Addendum No. 02

Title: North Bay Station Upgrades

**ONTARIO BUS AND TRAIN STATION
TICKET COUNTER AND BARRIER FREE WASHROOM UPGRADES
PROJECT NO. 6649B**

M/E ADDENDUM NO. #1

5 CASEWORK SECTION DETAILS
A1.02 SCALE 1:50

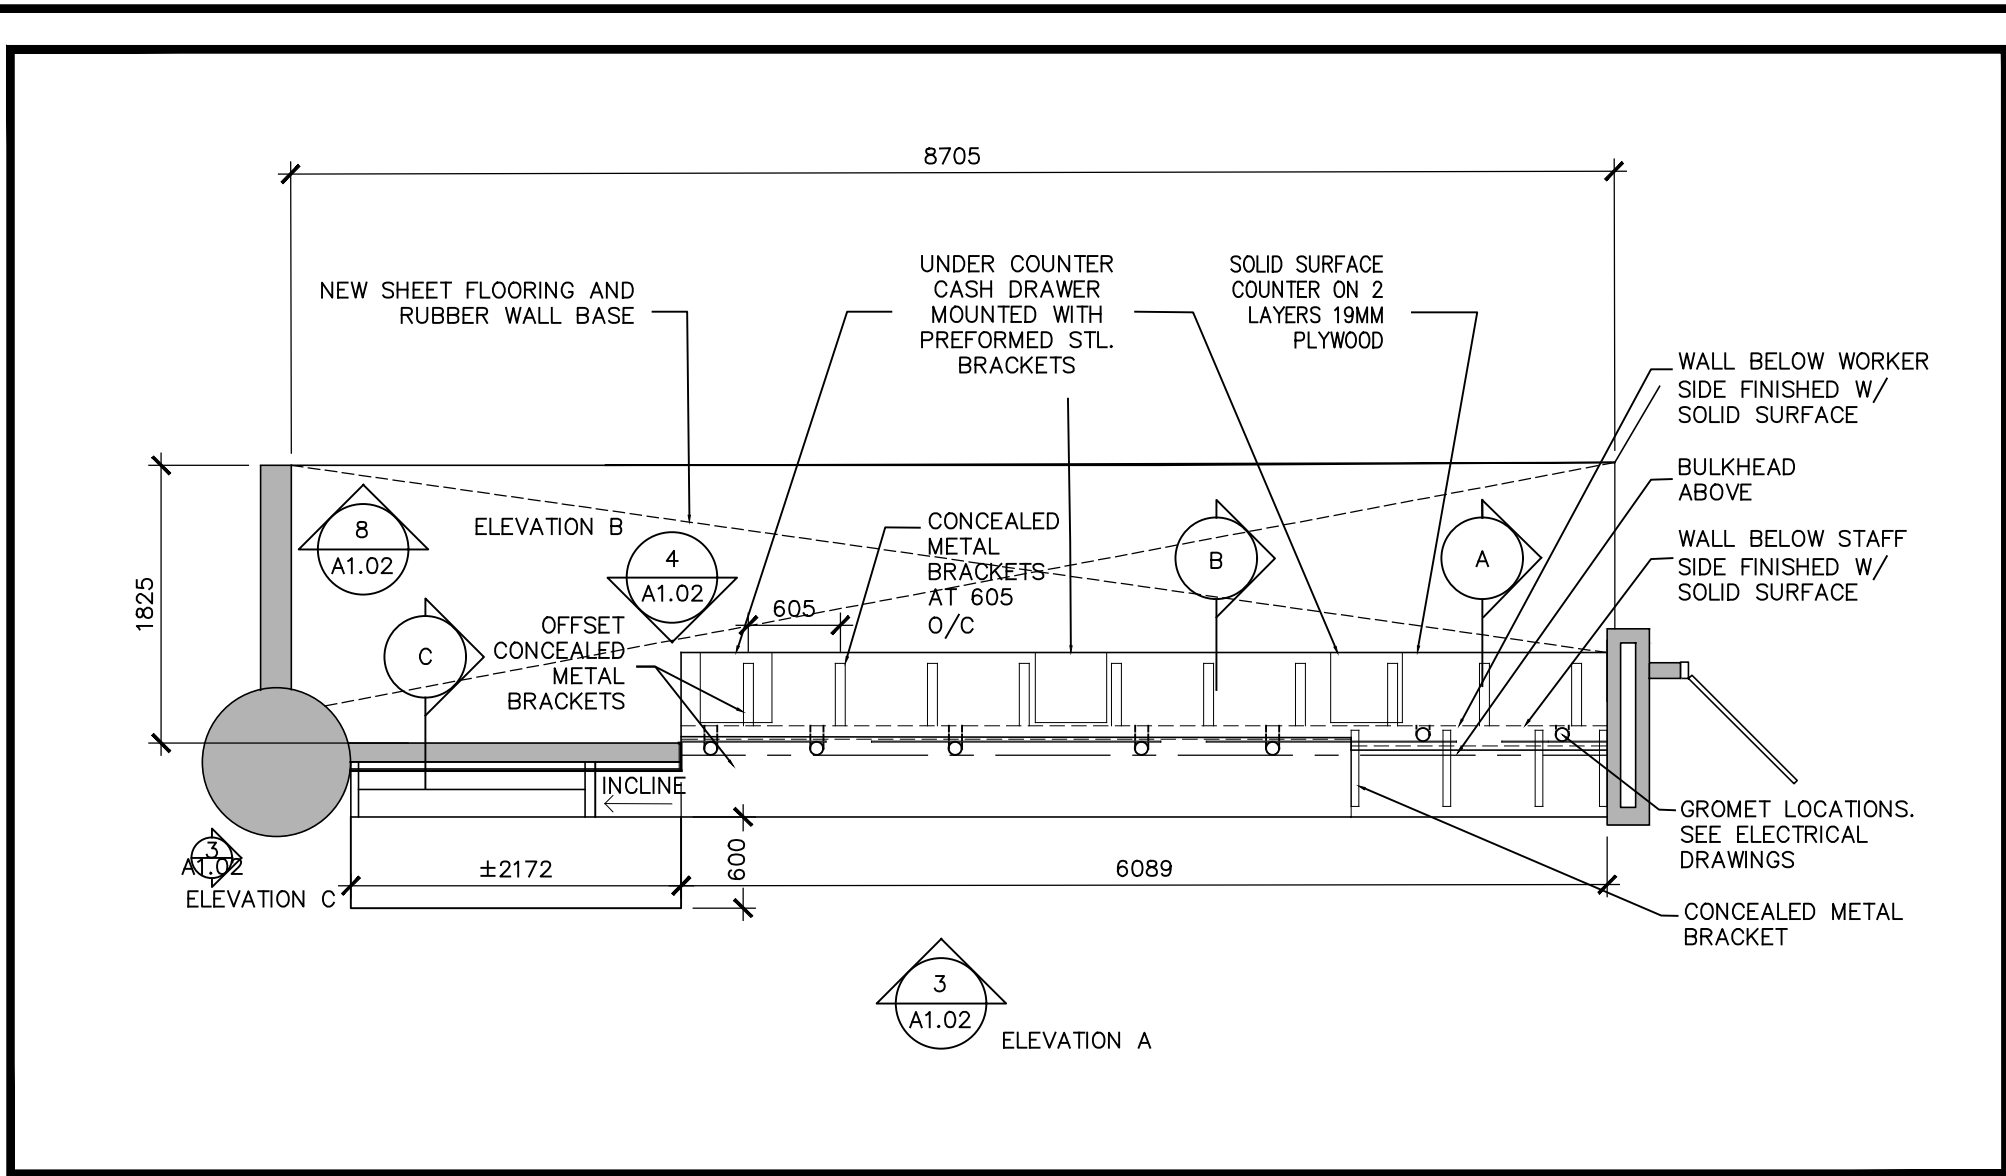
Question 7: Please confirm how the glass at the ticketing counter will be connected to the countertop, as shown in Section B (5/A1.02).

Answer 7: Glass at the countertop to float. No attachment at the countertop.

8 INTERIOR ELEVATION WORKING SIDE
A1.02 SCALE 1:50

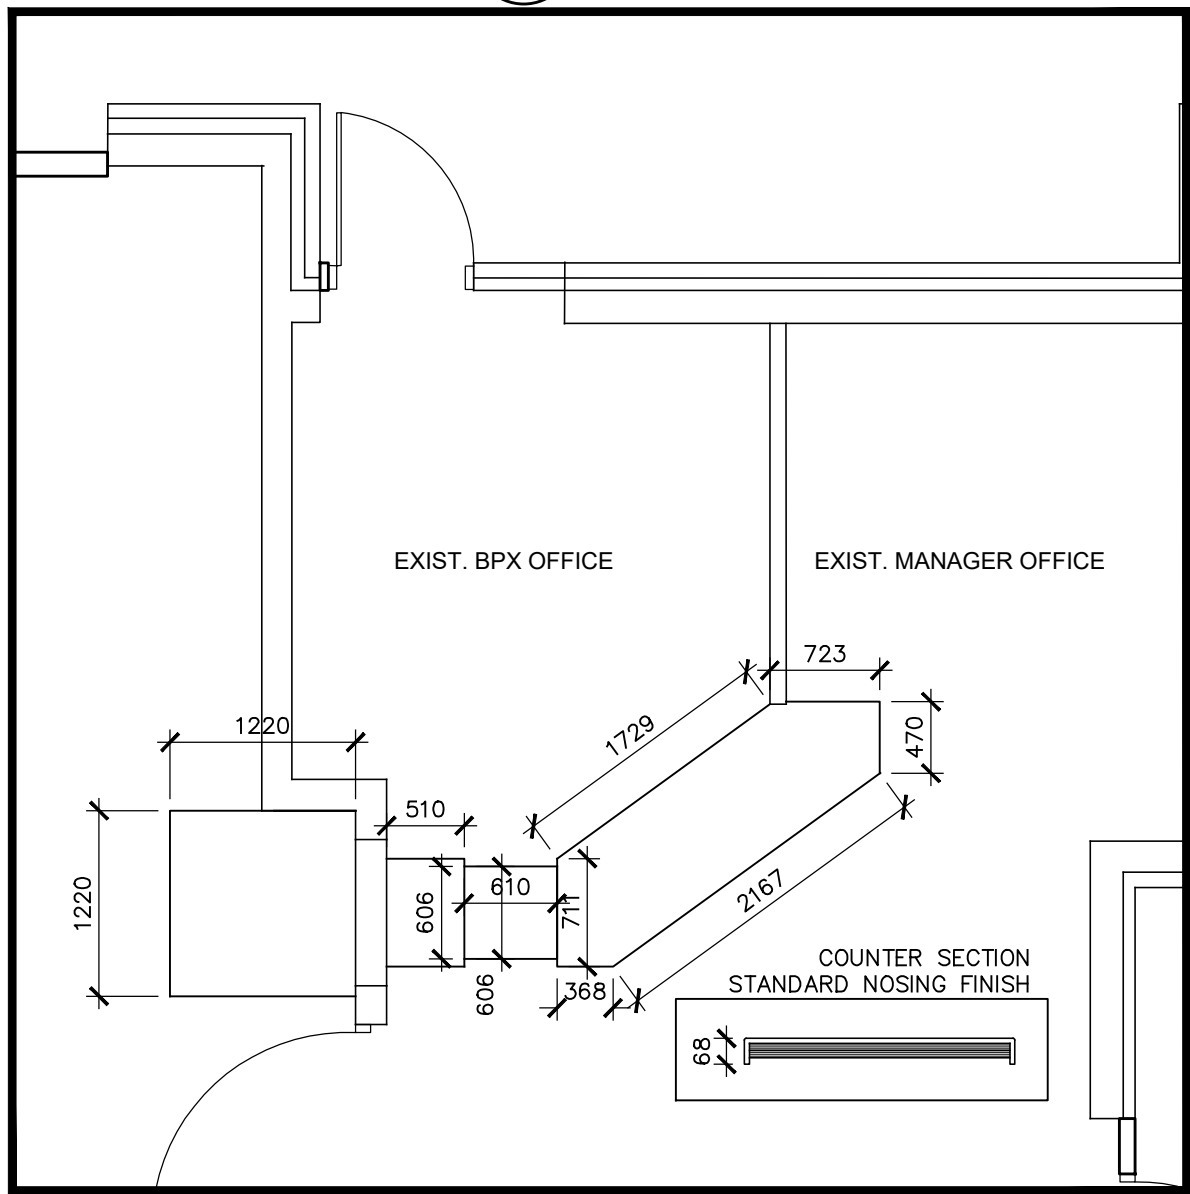
Item 7: Please confirm if tile backer board is required behind the wood paneling at Ticket Sales Counter, Elevation 8/A1.02.

Item 9: There is also a **back wall c/w reveal** there is no material specification or a cross-section detail showing the reveal condition.

Answer: Tile Backer Board is not required behind the wood panelling at the Ticket Sales Counter. Install horizontal 16mm wood furring strips on existing wall at 600mm centres and fasten wood panelling to wood furring strips. Wood furring is recommended in order to establish a level and flat application of the panelling. Shim wood furring strips if necessary.

Answer: All wood panelling located in washrooms and at ticket counter per drawing 8/A1.02 is to be plastic laminate (natural maple wood grain pattern - exact selection to be determined by Consultant post tender) on 19 mm MDF. Provide laminated plastic backing sheet: Grade BKL, 0.5 mm thick or same thickness as face laminate. All edging to be 3 mm thick PVC, colour to match face laminate. All panel reveals to be butt reveals. All fasteners to be concealed. Exposed fastening will not be accepted
